Intersection ID: 44463	Main Street: BUCKHORN_ST	Cross Street: VALCOURT_RD	Location:	NW
ADA ID: 893C23B2153C	Ramp Type: PerpDiag	Initial Pass/Fail: Fail	Overall Compliance: No	Severity Score: 21.25

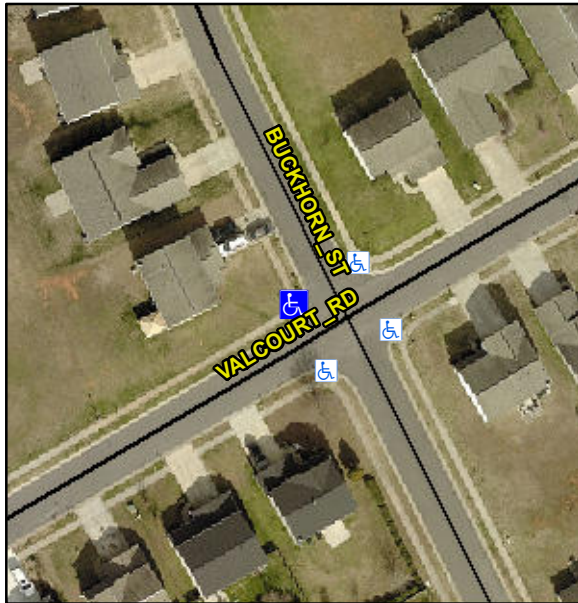
### R304.5.1, R304.2.2

Compliance	Description	Data	Compliance	Description	Data
N/A	Ramp Length (in)	50.5	No	Ramp Slope (%)	9.1
No	Ramp Width (in)	38.5	Yes	Ramp XSlope (%)	1.6
N/A	Flare Type LT	N/A	N/A	Flare Type RT	N/A
N/A	Flare Slope LT (%)	N/A	N/A	Flare Slope RT (%)	N/A
N/A	Flare Traversable LT?	N/A	N/A	Flare Traversable RT?	N/A
N/A	Landing Length (in)	N/A	N/A	DWS Provided?	N/A
N/A	Landing Width (in)	N/A	N/A	DWS Contrast?	N/A
N/A	Landing Slope (%)	N/A	N/A	DWS Length (in)	N/A
N/A	Landing X Slope (%)	N/A	N/A	DWS Full Width?	N/A
N/A	Landing Curb? (Y/N)	N/A	N/A	DWS Offset (in)	N/A
N/A	Shared Landing?	N/A			
N/A	Gutter Ponding?	N/A	N/A	Gutter Slope (%)	N/A
N/A	Gutter Lip Ht (in)	N/A	N/A	Gutter X Slope (%)	N/A
N/A	Painted X Walk1?	No	N/A	Painted X Walk2?	No
	X Walk 1 Direction	To S		X Walk 2 Direction	To E
N/A	X Walk 1 Width (in)	N/A	N/A	X Walk 2 Width (in)	N/A
	X Walk 1 Slope (%)	5.9		X Walk 2 Slope (%)	1.5
	X Walk 1 X Slope (%)	1.2		X Walk 2 X Slope (%)	2.6

**Remove & Replace Curb Ramp With Two New Directional Ramps or Equivalent.**
